Reserved Matters Application including access, layout, landscaping and scale pursuant to Outline Planning Permission 14/02121/OUT for internal Primary and Secondary Streets along with the part discharge of conditions 12, 16, 17 and 19 for Phase 1B at Himley Village, Bicester

Further to discussions with yourself and Officers at Oxfordshire County Council Highways Department I am submitting a revised scheme pursuant to Reserved Matters application 23/01493/REM for Phase 1B, Himley Village, Bicester.

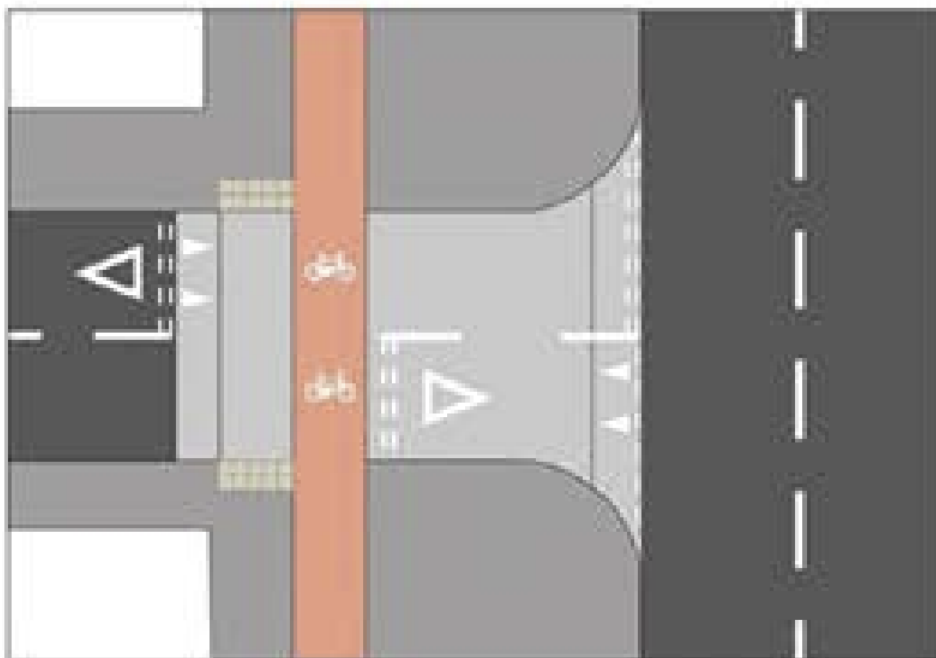
BBUG Comment 1:

"All of the cycle crossings over minor roads require priority access in accordance with Local Transport Note 1/20 (LTN 1/20), OCC's Cycle Design Standards, and the Bicester Local Walking and Cycling

Infrastructure Plan (LCWIP). Without priority access, the cycle lanes become essentially useless and most cyclists will either cycle on the main carriageway posing a risk to themselves and an annoyance to motor vehicle drivers.”

Cala Homes Response:

In consultation with OCC Highways (and in agreement with the BBUG comments), the proposed cycle crossing arrangements have been updated to provide priority access to cyclists across the onsite roads. Where crossing points are located adjacent to the main spine roads, the crossings incorporate a 5 metre set back from the main carriageway, lining / signage (to be shown at detailed design stage), tactiles for pedestrians and raised tables / ramps. It is proposed for the priority access over carriageways to be implemented using the principles shown in LTN 1/20, Figure 10.13:

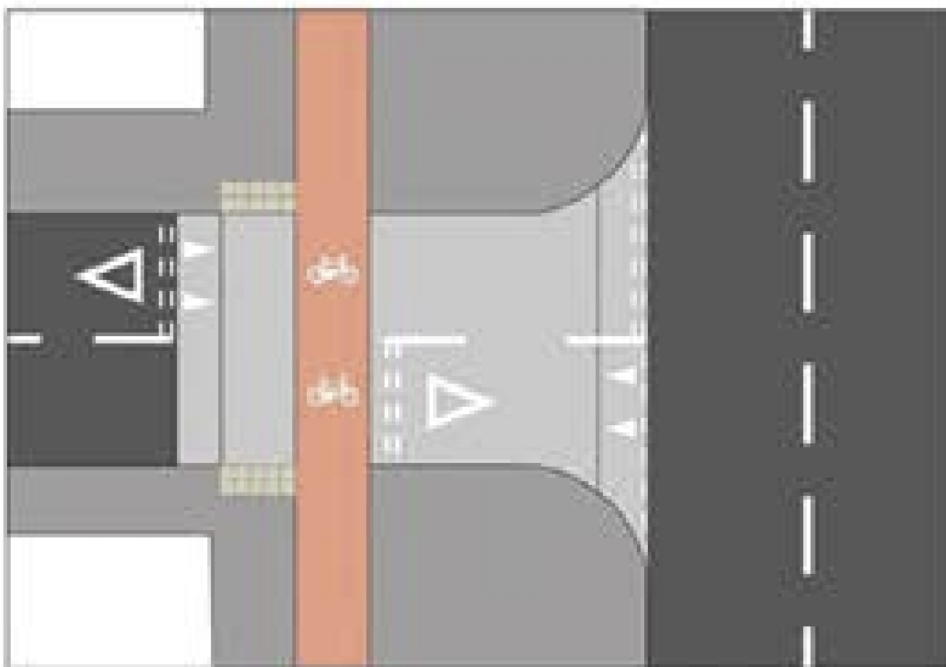
“The provision of segregated walking and cycling infrastructure on both sides of the Primary Spine Road was previously welcome. However, the revised Phase 1B Infrastructure Reserved Matters Red Line Boundary Plan lacks any obvious treatment at side roads, which will require pedestrians and cycles to give way to vehicles. This will inconvenience / discourage active travel movements. ATE encourages the applicant to adopt approaches set out in either Figure 10.13: Priority crossings of cycle tracks at side roads or Figure 10.15: Full set back, marked priority (bent out) crossing within LTN 1/20.”

Cala Homes Response:

As per the response to the BBUG comment, in consultation with OCC Highways (and in agreement with the ATE and BBUG comments), the proposed cycle crossing arrangements have been updated to provide priority access to cyclists across the onsite roads. Where the crossing points are located adjacent to the main spine roads, the crossings incorporate a 5 metre set back from the main carriageway, lining / signage (to be shown at detailed design stage), tactiles for pedestrians and raised tables / ramps. It is proposed for the priority access over carriageways to be implemented using the principles shown in LTN 1/20, Figure 10.13:
